PROJECT: North Castle NY - JG Petrucci DATE: 7/12/2021
 2179-99-009
 SUBJECT: 94 Business Park Drive TRANSMITTAL ID: 00006
 PURPOSE: For your use VIA: Info Exchange

**RE: Armonk Fairview, LLC &
Aggro and Brassi, LLC
Proposed Warehouse
Section 108.03; Block 1; Lot 50
94 Business Park Drive
Town of North Castle (Armonk)
Westchester County, NY
DEC #2179-99-009**

The following are responses to an engineering review letter prepared by Kellard Sessions dated March 5, 2021:

TITLE: **DRIVEWAY PROFILES**

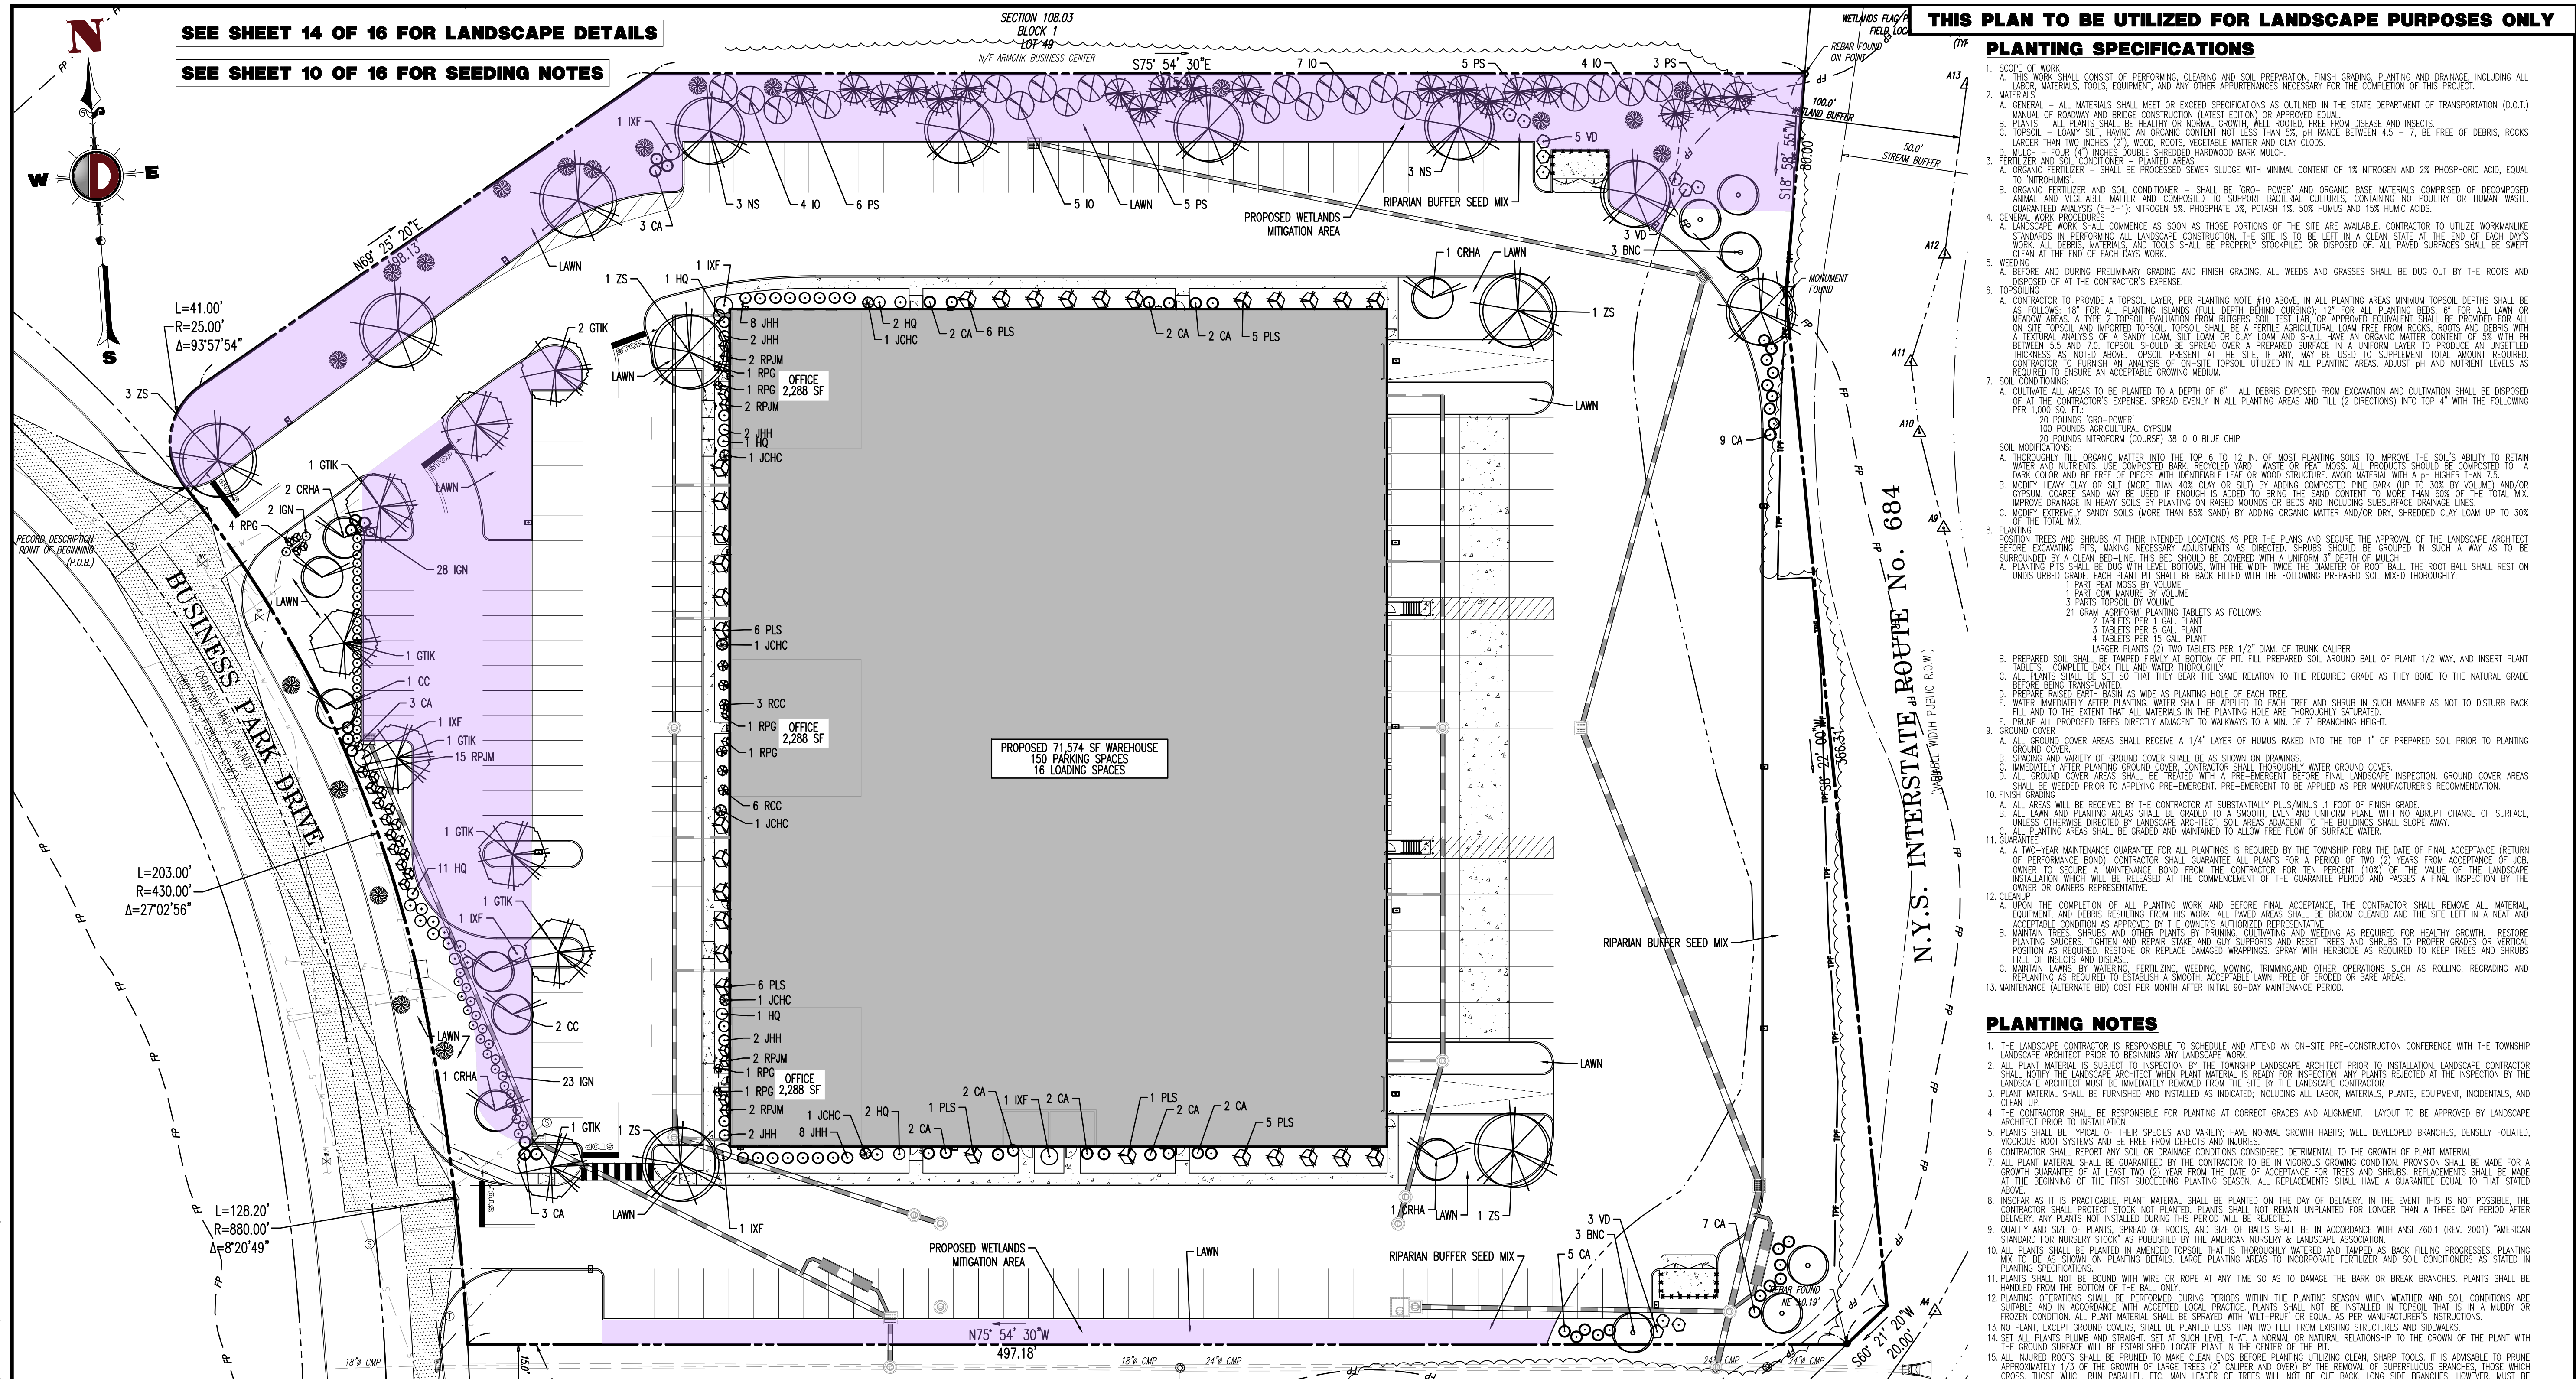
8. The site plan indicates available sight line distances for vehicles exiting both proposed driveway locations. The plan, however, should be expanded to illustrate the entirety of the available sight distance, as well as include sight line profiles for these locations. The profile shall be taken from a vehicle 14 feet from the edge of the traveled way, with the driver's eye at 3.5 feet above finish grade, to an object in the road 2 feet above grade. The plan should identify whether any additional existing vegetation along the right-of-way of Business Park Drive will require removal to maintain adequate sight lines.

11. The plan shall include proposed driveway profiles to demonstrate compliance with Section 355-59, Driveways of the Town Code.

The plan has been revised to show the sight line profiles. The sight line is complete in the roadway, as there are no obstructions.

The plan has been revised to show proposed driveway profiles.
